STAFF RECOMMENDATION
300 Broadway
August 21, 2019

Application: Alterations—Exterior lighting
District: Broadway Historic Preservation Zoning Overlay
Council District: 19
Zoning: DTC
Map and Parcel Number: 09306308200
Applicant: Erica Garrison, Waller Lansden
Project Lead: Robin Zeigler, robin.zeigler@nashville.gov

Description of Project: The request is to change the color of building illumination of previously approved light fixtures from white-only to white or red and to approve colored illumination installed without a permit on the rooftop addition. **Recommendation Summary:** Staff recommends disapproval of the request to retain colored building illumination and recommends that the rooftop lighting, installed without a permit, be removed, finding that the proposal does not meet Section II.T. of the design guidelines for lighting in the Broadway Historic Preservation Zoning overlay.	**Attachments** **A:** Applicant's letter and application **B:** July 19, 2017 Staff Recommendation regarding building illumination policy

Figure 1: This image, taken from 3rd Avenue South and within the historic overlay, shows the red lighting that caps the rooftop addition.

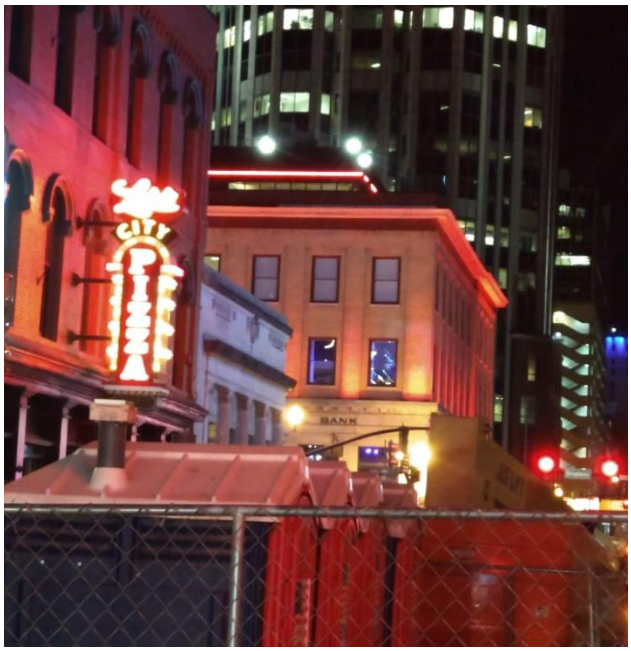
Location & Direction: The location and direction of lighting fixtures on the façade have been approved with the administrative permit; however, lighting was also installed on the rooftop addition without a permit.

The design guidelines allow for exterior lighting if it is concealed or unobtrusive. The lighting on the addition is inappropriate as the addition should be as minimally visible as possible. Illumination of the top of the addition will only draw attention to the new construction, which is not the intent of the design guidelines for rooftop additions, which states that additions should "not be visually jarring or contrasting" to the historic building.

In addition, light should be directed towards the façade rather than outwards. The lighting on the rooftop is directed away from the building and is therefore inappropriate. Staff recommends removal of the lighting on the addition.

Recommendation Summary:
Staff recommends disapproval of the request to retain colored building illumination and recommends that the rooftop lighting, installed without a permit, be removed, finding that the proposal does not meet Section II.T. of the design guidelines for lighting in the Broadway Historic Preservation Zoning overlay.

SOUTH ELEVATION LIGHTING

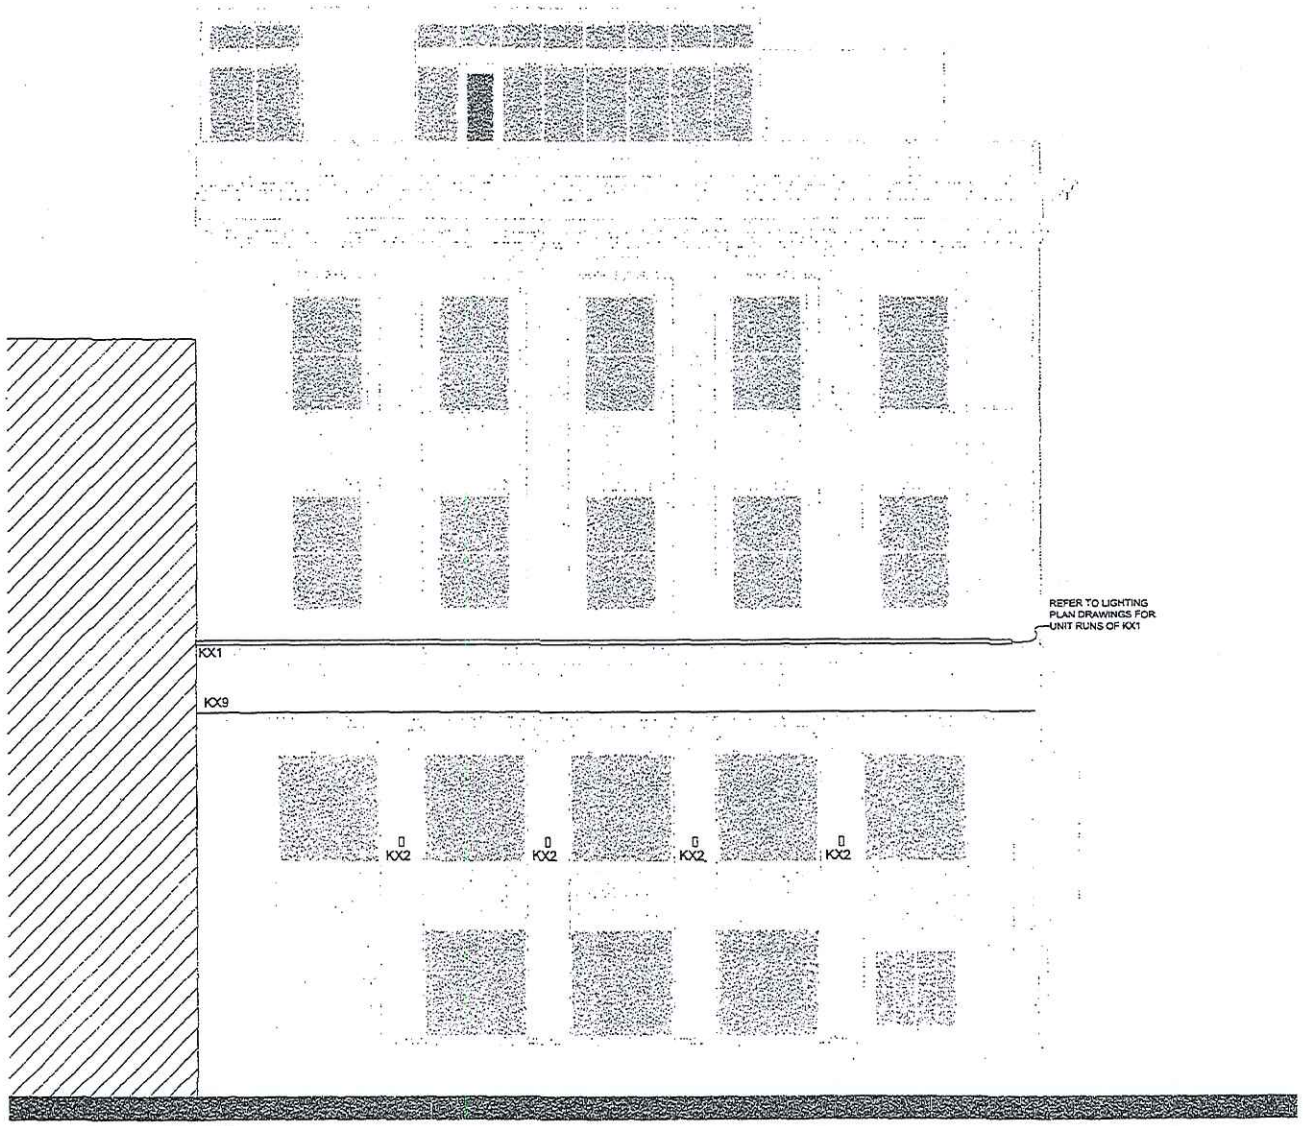
Design: The drawings note that the lights change colors. Illumination should be white as colored lights change the color of the building and would detract from the historic character of the building. Essentially changing the color of the building with illumination does not meet Section T.1 of the design guidelines, which calls for lighting to be "unobtrusive."
